Tree warden comments on application

Notes added 11th August 2022 in response to the revised application. Changes to the previous comments are shown in red

DC22 0495 FUL Chapel works

Plan showing the landscape plan drawn by me in 1990 for B & M concrete. It is also the site of a former golf green. North is to the left.

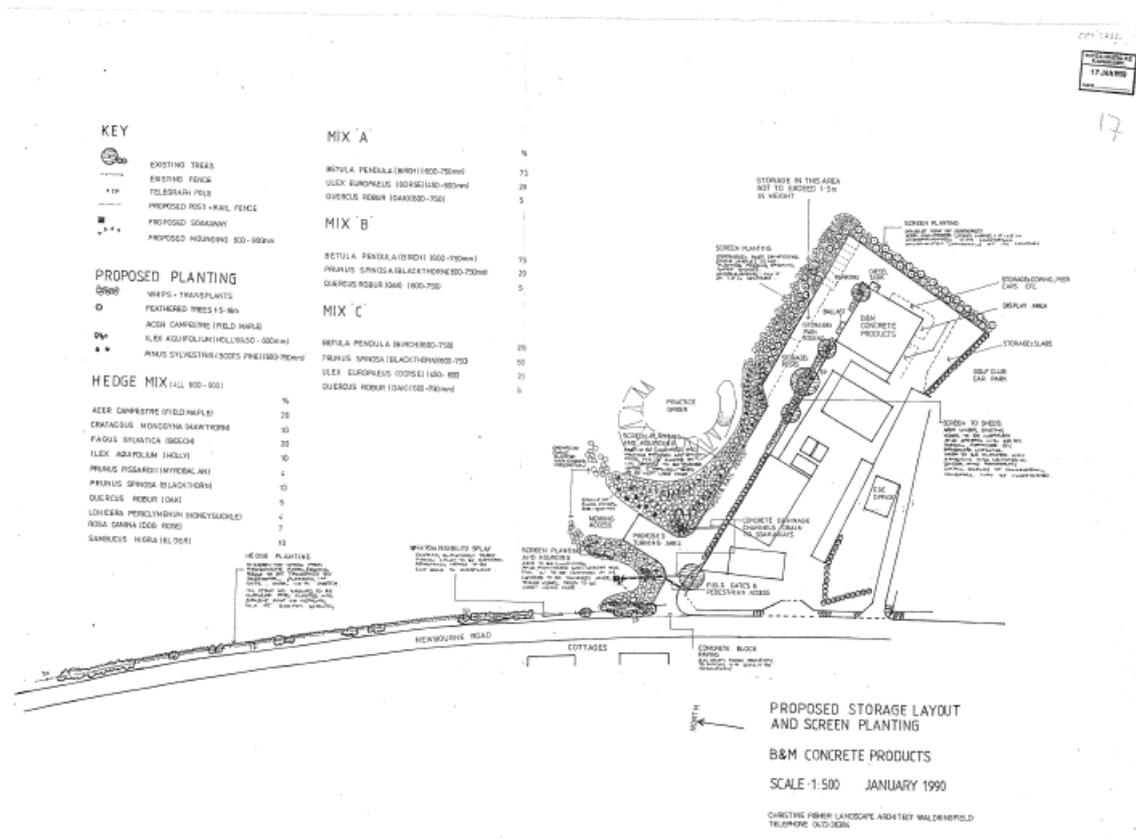
This photo shows heaps of material possibly brought in as bottoming for a hard area. These are on the site of a stand of mainly birch trees recently removed by the applicants. These were planted as part of the approved landscape plan which was meant to screen the premises of the former B & M concrete from view.
